UNITED STATES PATENT AND TRADEMARK OFFICE

Office Action Summary	Application No. 10/531,272	Applicant(s) SCHIMANZ, GERHARD	
	Examiner Mark T. Vogelbacker	Art Unit 3677

DETAILED ACTION

Fig. 2

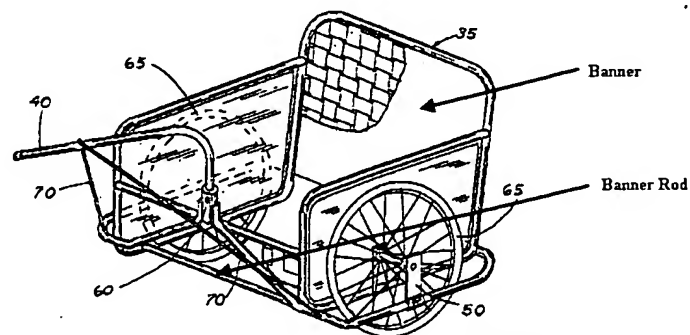
7. Claims 1-4, 9 and 13-15 are rejected under 35 U.S.C. 102(b) as anticipated by French et al., US-4,381,117.

Boyce discloses the invention as claimed, including a banner and a banner rod that can be coupled to an aircraft via a banner spider (70) and a tow rope (40). Two round disks (65) are pivotally mounted on the banner rod and a weight (30) is on one end of the banner rod.
